UNITED STATES PATENT AND TRADEMARK OFFICE

APPLICATION NO.	FILING DATE	FIRST NAMED INVENTOR	ATTORNEY DOCKET NO.	CONFIRMATION NO.
10/612,374	07/01/2003	Ki Rin Sung	DE-1489	3709

Office Action Summary	Application No.	Applicant(s)	
	10/612,374	SUNG, KI RIN	
	Examiner	Art Unit	
	Noah C. Hawk	3636

DETAILED ACTION

Applicant's Disclosed Prior Art, Figure 2

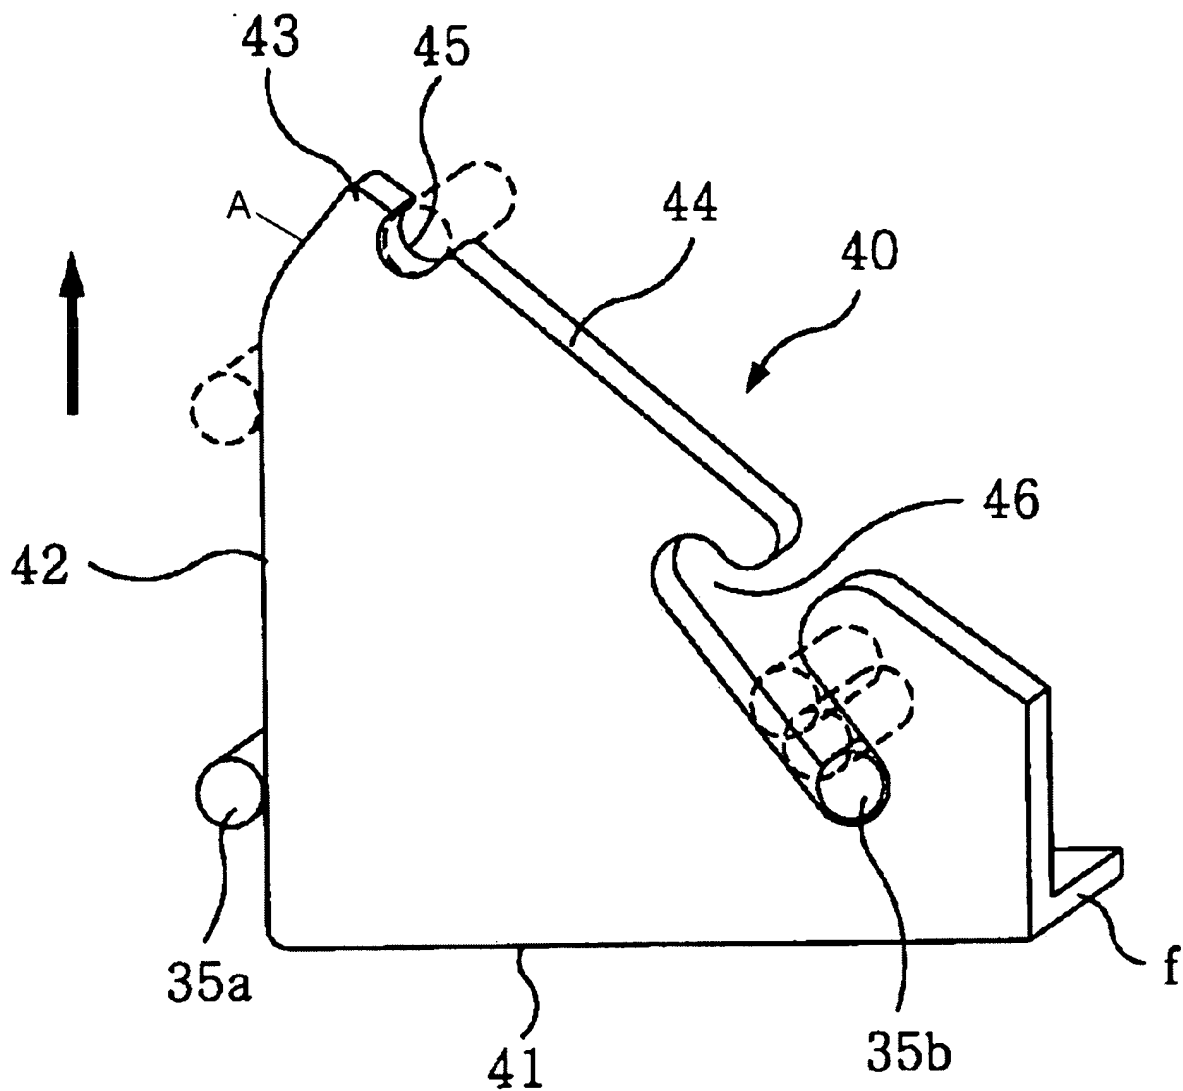
6. Claims 6 and 8-10 are rejected under 35 U.S.C. 103(a) as being unpatentable over applicant's disclosed prior art in view of Miller and Canfield. In the Background of the Invention, the applicant discloses a pan holder (page 1, line 19), surrounded by an insulated wall (page 2, line 3), using 2 brackets per cover (page 3, lines 9-11), which have a slanted guiding surface (Fig 2, A) for guiding a first hinge axle, the cover having two opposite sides (see Figure 1), a pair of first hinge axles (Fig 1, #26a), and a pair of second hinge axles (Fig 1, #26b) wherein the pair of first hinge axles are closer to a center portion of each of the covers than the pair of second hinge axles (best seen in Figure 2). The disclosed prior art does not teach an insulating wall with a flat top surface. Miller discloses an insulating wall (11c) with a flat top surface (best seen in Miller, Figure 4) to prevent items from rolling off. It would have been obvious to one of ordinary skill in the art at the time of invention to modify the device of the disclosed prior

art by using an insulating wall with a flat top surface as taught by Miller in order to prevent food items from rolling or sliding off the top of the wall when the device is used.

Canfield, Figure 6

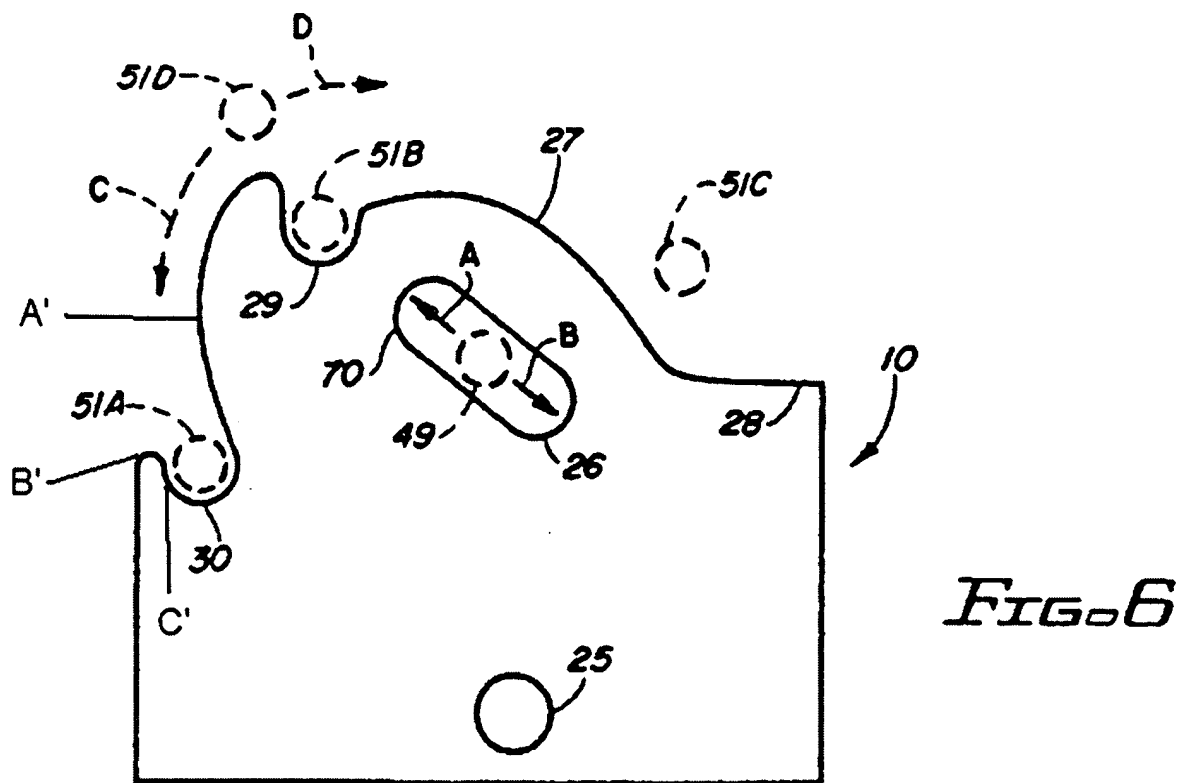
The device of the disclosed prior art, as modified by Miller, fails to teach a curved slant surface, a guide opening parallel to the top surface of the insulated wall, a support portion at a lowest portion of the guide surface, or a front protrusion opposite the guide surface. Canfield teaches providing a bracket (10) with a curved slant surface (A'), a guide opening (26) for guiding one of the hinge axles that can be mounted to extend parallel to the top surface of the insulated wall (see Canfield, Column 3, line 47-50. The phrase "to pivotally connect end... to hinge member" teaches that the hinge member can be mounted in any orientation, therefore, this Canfield teaches a bracket that, when properly mounted, provides a guide opening extended parallel with the top surface of the insulated wall), a support portion (30) which is disposed at the lowest portion of the guide surface and a front protrusion (B') connected to the support portion and opposite to the guide surface. It would have been obvious at the time of invention to one skilled in the art to modify the device of the disclosed prior art in view of Miller to use the bracket as disclosed by Canfield in order to improve the ease of opening the cover.

9. Regarding the applicant's argument that the curved surface A' of Canfield is not a guide surface: it is reasonable to assume that the pin 51 will begin in detent 30, which, as applicant points out, will mean that the curved *will be used* as a guide surface.

Showing pin 51 in position 51D is merely an example of a possible path for the pin during movement.

10. Regarding the applicant's argument that the curved slant surface of Canfield is not at slant, the applicant is directed to look at the end portions of the surface – they are clearly slanted.
